**Northeast Oregon Hatchery Program  
Grande Ronde - Imnaha Spring Chinook Hatchery Project  
Supplement to Biological Assessment**

**March 2006**

This document represents a supplemental analysis to the BA previously submitted to the USFWS and NOAA Fisheries (Services) to update project reviewers on design changes and anticipated impacts those changes may have on listed species. In addition, this document considers updates to the critical habitat listings for Columbia River bull trout (*Salvelinus confluentus*) and for Snake River steelhead (*Oncorhynchus mykiss*) and recommends effect determinations for those designated habitats. The project has previously undergone formal ESA consultation (effect determination for all listed anadromous species was Likely to Adversely Affect); proposed project changes do not affect this determination and are not anticipated to result in impacts that exceed the level of take previously authorized in the BOs prepared for this project.

Figure 8. Current Immaha Satellite Facility Site Plan.

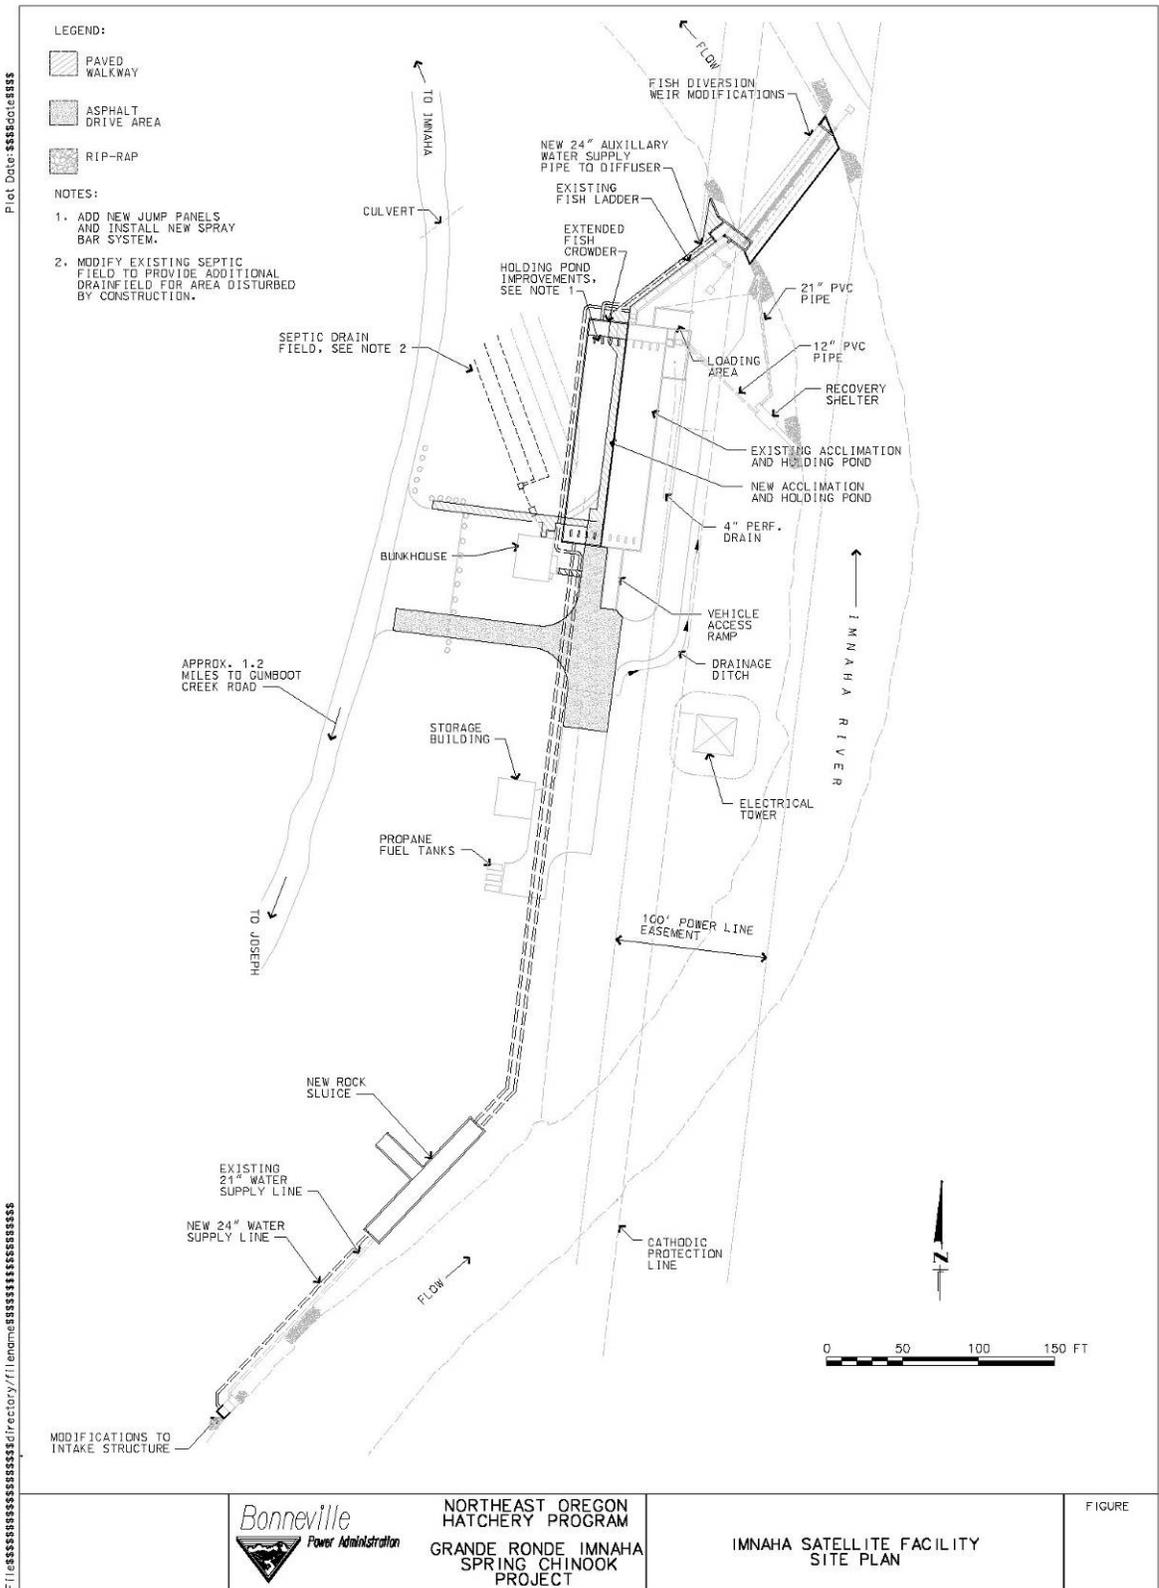
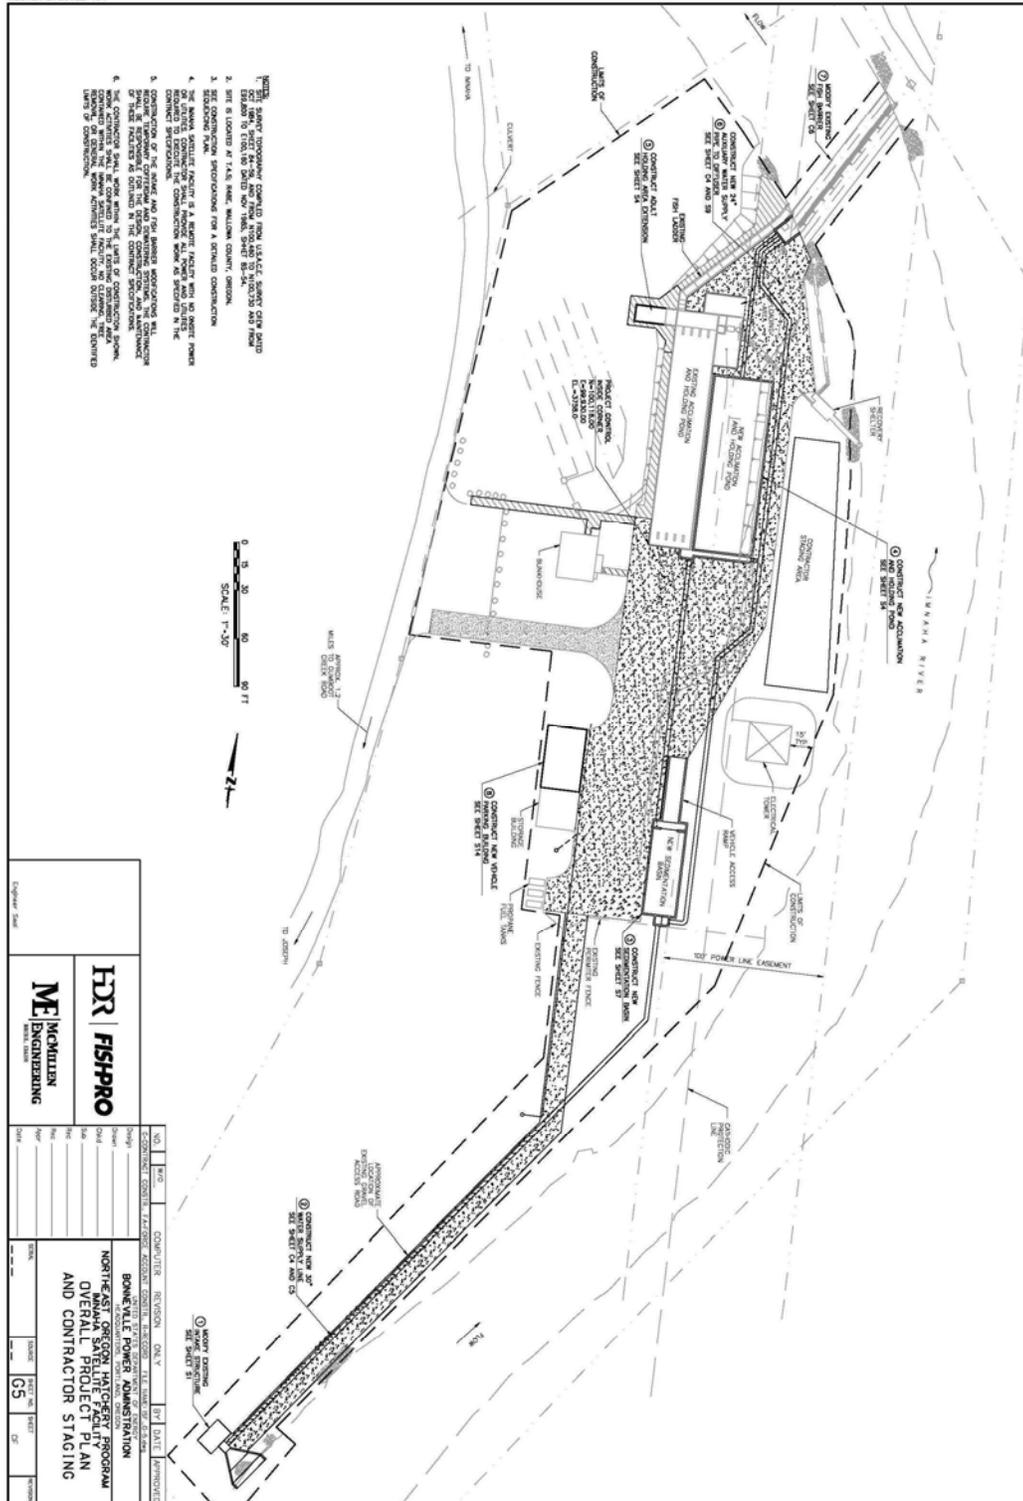
Minor modifications to the original site plan are proposed at the Innaha Satellite Facility. The new site plan (see Figure 8) includes:

- Relocation of the intake rock sluiceway to a settling basin east of the existing storage building
- Redesign of the new acclimation and holding ponds to the east side of the existing holding ponds
- Extension of the existing storage building and addition of vehicle parking area
- Relocation of the vehicle access ramp
- Addition of adult holding area extension
- Additional portable generator and skid-mounted air compressor for pneumatically-controlled weir and intake screen cleaning
- Pre-manufactured equipment panel and building for pneumatically-controlled weir
